Application for Certification (15-AFC-01)

Puente Power Project (P3)
Oxnard, CA

Responses to City of Oxnard Data Requests Set 4

December 2015

**APPENDIX 94-1
PRELIMINARY CALCULATIONS**

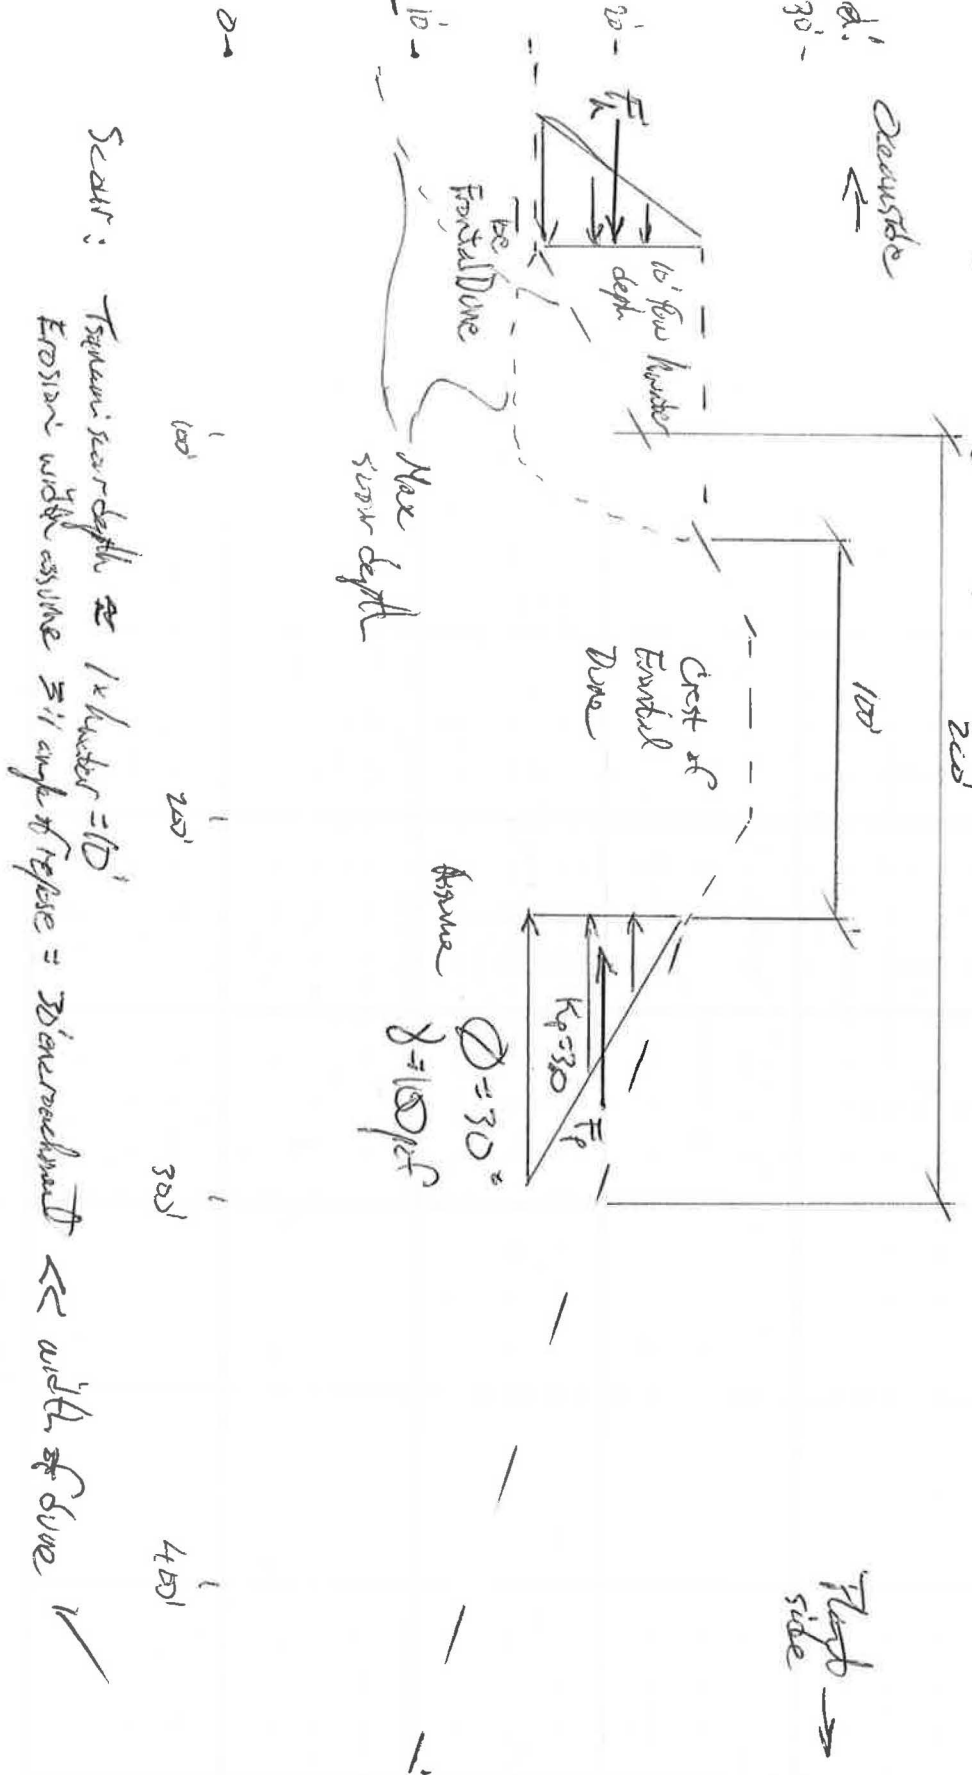
- 94. In response to City Data Request No. 62, the applicant mentions preliminary calculations to evaluate the potential stability of dunes and dikes. Please provide all analysis, methods and associated results (calculations) used to draw the conclusions presented in the response on page 62-1.**

The preliminary calculations on the stability of the dunes fronting the MGS against tsunami impact were based on evaluating basic scour conditions and factor-of-safety against slope instability. The load and resistance inputs are based on a flow depth of 10 feet at the dune, applied to the generalized topographic cross section where the dune toe represents the bottom of the loading, and the dune crest is a few feet above the water level. The dune width serves as the basic feature providing resistance to scour by allowing “waste” erosion during the attack. Similarly for slope stability, the sliding friction across the dune width serves as the primary reaction to resist tsunami wave forces acting in shear loading.

For tsunami scour, Federal Emergency Management Agency (FEMA) P-646 (FEMA, 2012) and Francis 2007 provide basic relationships for beach sands. Maximum scour depth can be estimated to be approximately equal to the flow depth. These guidelines also provide hydrostatic and hydrodynamic force equations. Terzaghi et al. (1996) provide basic geotechnical relationships for soil index properties, in situ stresses, shear strength, and sliding resistance.

The broad dune width is shown to provide ample resistance to both estimated extent of scour and shear loading from the design tsunami wave forces.

The preliminary calculations are provided in Appendix 94-1.
